ST	EREO IMPACT SWEA LVPS -	2/19/2004	
Re	questing Engineer:	Date: 4-15-04	
Ар	proved by:	Date: \(\frac{\fin}}}}}}{\frac}\frac{\fra	
Ap	proved by:	Date:	
	STEREO IMPACT SWEA LVPS RI	EWORK INSTRUCTIONS	
1.	Wiring rework is required for U1.		
	Several connections for U1 pins 9-16 need to be corrected; the following wiring modifications are needed to make the corrections.		
	Cut the trace between pins 6 and 13 under t #1838 B/A Green epoxy.	the IC, as shown in Figure 1 below. Cover the cut with	
	COMPLETED BY	_ DATE	
	Cut the trace between pin 12 and the ground #1838 B/A Green epoxy.	d via, as shown in Figure 1. Cover the cut with	
	COMPLETED BY	_ DATE	
	 Cut the trace between pin 15 and C12, as si epoxy. 	hown in Figure 1. Cover the cut with #1838 B/A Greer	
	COMPLETED BY	_ DATE	
	4) Clip off pin 9 to make that pin a No-Connect		
	COMPLETED BY	_ DATE

STEREO IMPACT SWEA LVPS	2/19/2004
Requesting Engineer: Daw Hone	Date: 4-15-04
Approved by: Rely Bung	Date: <u> </u>
Approved by:	Date:

Figure 1

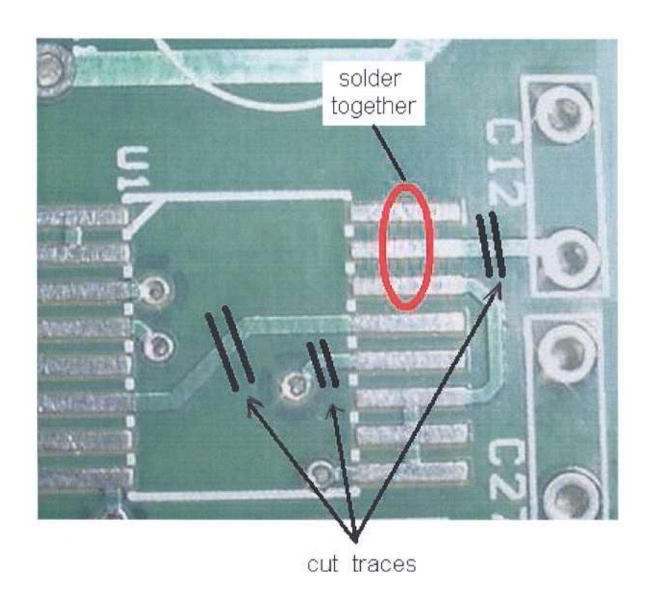
STEREO IMPACT SWEALVPS			2/19/2004
Requesting Engineer: 1000			ate: 4-15 34
Approved by: Zity Bung			ate: _ \
Approved by:			ate:
5) Solder pi	ns 11, 12, 13, 14, 15 and 16 to thei	r pads normally.	
2 8		1) %	
COMPLETE	D BV	DATE	
COMPLETE	D BY	DATE	-2
below. In	6) Remove C12. Connect a wire from U1 pin 10 to the lead on a new C12 as shown in Figure 2 below. Install the new C12 with the jumper wire attached. Install Kapton tape to insulate U1 pin 10 from its pad.		
COMPLETE	D BY	DATE	
7) Solder a wire to pin 12, run it over the top of the IC, and solder it to pin 6.			t to pin 6.
COMPLETE	D BY	DATE	
65 EF-35			
Solder a wire to pin 13, run it over the top of the IC, and solder it to pin 3.			t to pin 3.
COMPLETE	D BY	DATE	
9) Solder pi	9) Solder pins 14, 15 and 16 together, using a jumper wire if necessary, as shown in Figure 1.		
COMPLETE	D BY	DATE	
COMPLETE	551	DATE

Figure 2

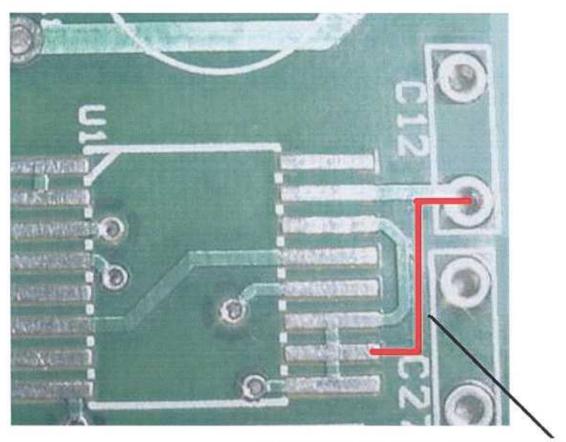
Jumper wire from U1-10 to C12 lead
